Nuclear Fuel Services, Inc.
P.O. Box 337, MS 123
Erwin, TN 37650

Subject: License Amendment Request Regarding 10 CFR 20.2003 Requirements

Nuclear Fuel Services, Inc. (NFS) hereby requests an amendment to the referenced license to clarify requirements regarding sampling and analysis of liquids discharged into the sanitary sewerage. Title 10, Code of Federal Regulations (CFR), Part 20.2003, *Disposal by Release into Sanitary Sewerage*, allows such discharges, provided, in part, that the quantity of licensed materials discharged does not exceed the concentrations listed in Table 3 of Appendix B of 10 CFR 20. If licensed materials are being discharged, sampling and analysis are required to verify compliance with the limits. However, if licensed materials are not being discharged into the sanitary sewerage, sampling and analysis should not be required. An example of the latter condition will be present at the Uranyl Nitrate Building (UNB) (Reference 2), where disposal of process water containing licensed materials into the sanitary sewerage will not occur. Therefore, to clarify the sampling and analysis requirements for discharges into the sanitary sewerage, NFS requests approval of p

Figure 10 16
NFS Inputs to the Sanitary Waste Stream

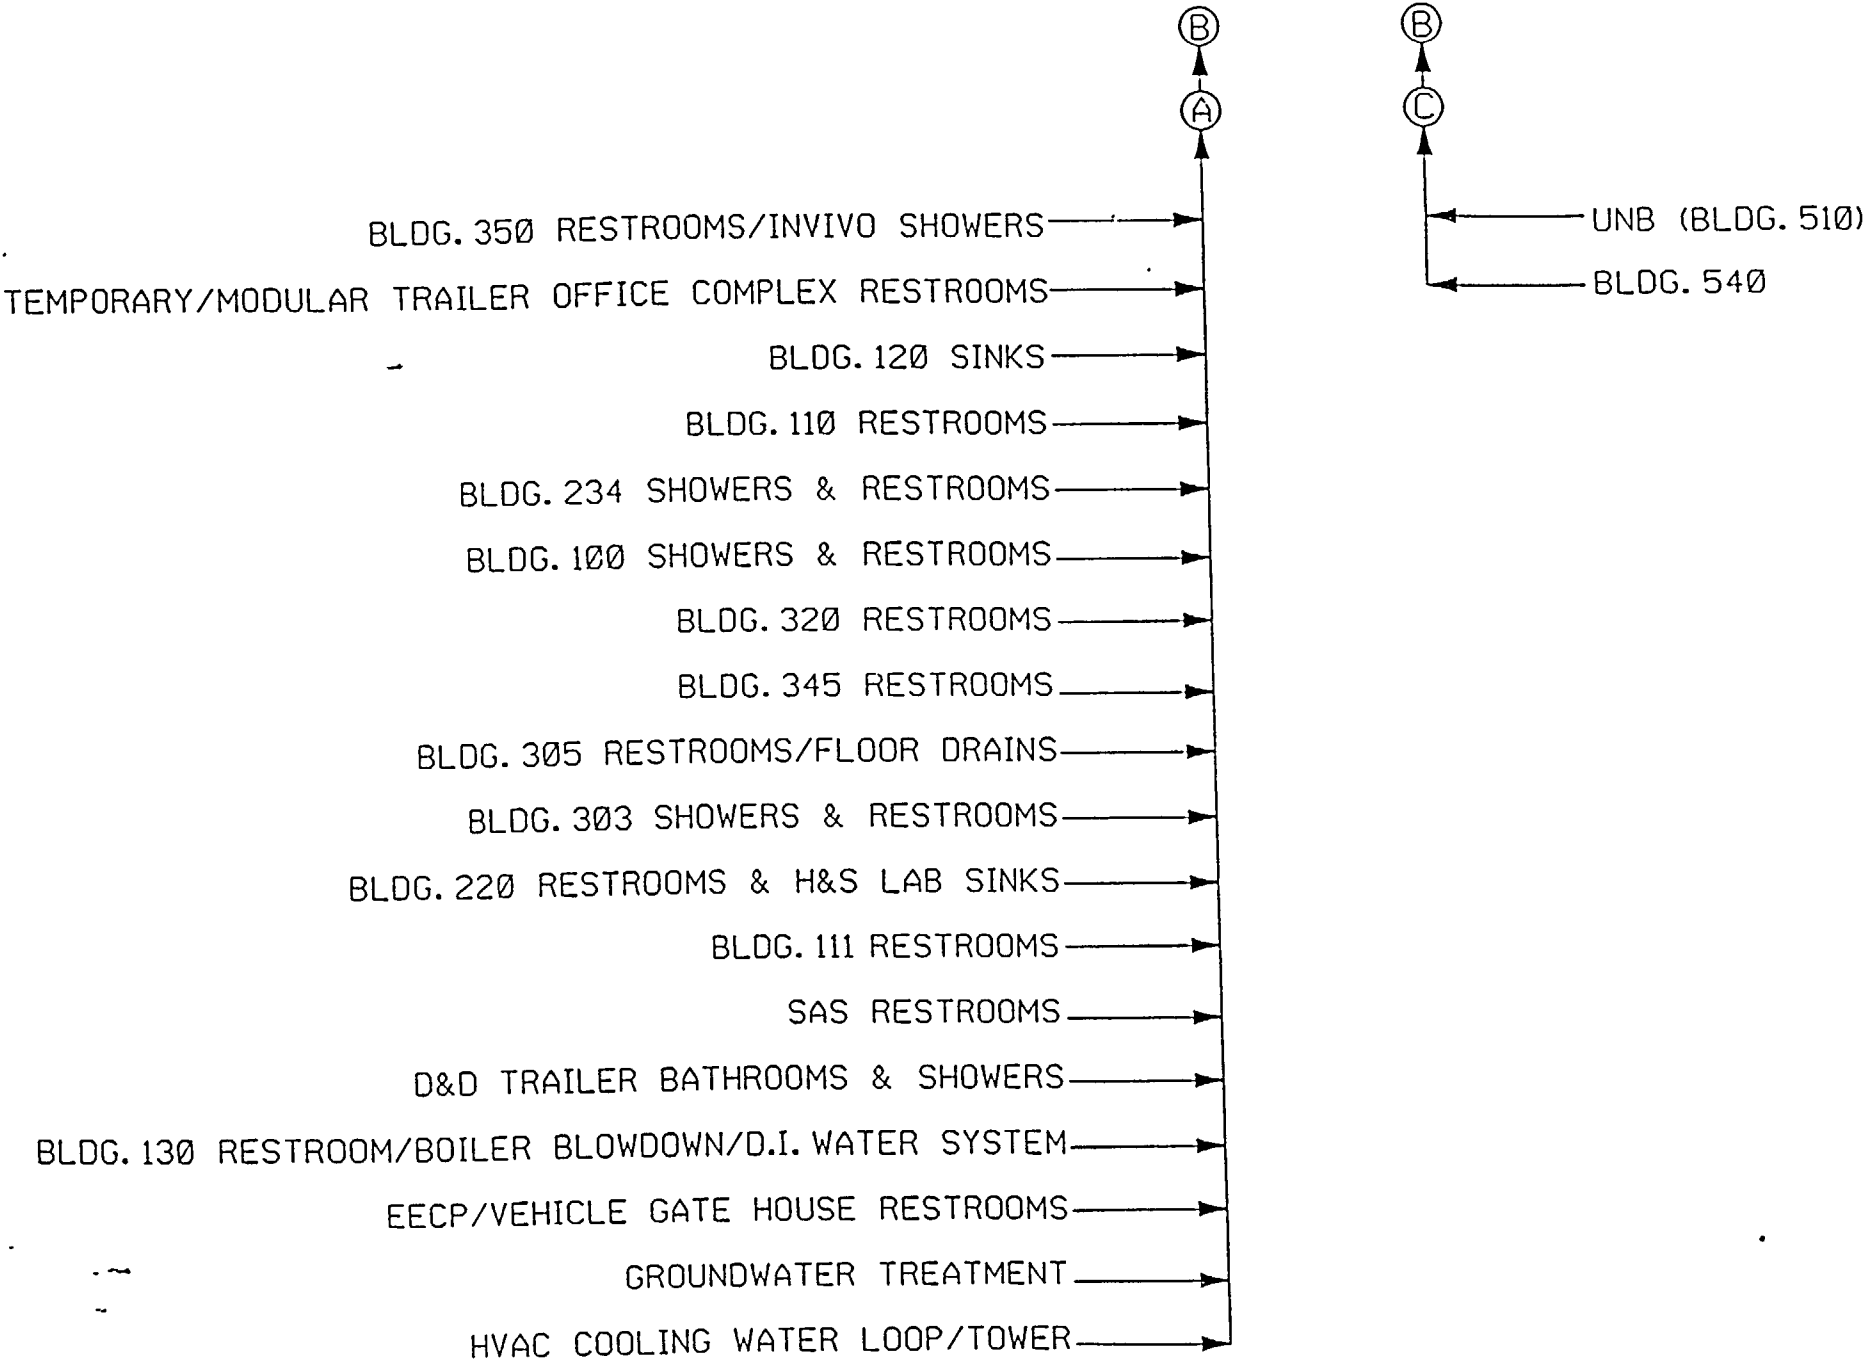
Plant sanitary wastes are discharged through piping which goes to the City of Erwin publicly owned treatment works. The inputs for the sanitary sewer system include all bathrooms and showers (as outlined in Figure 10.16). Water from the Groundwater Treatment Facility is also discharged in accordance with all applicable regulatory requirements. Effluent sampling is addressed in Chapter 5, Section 5.1.2.1 and Chapter 13, Section 13.3.2.
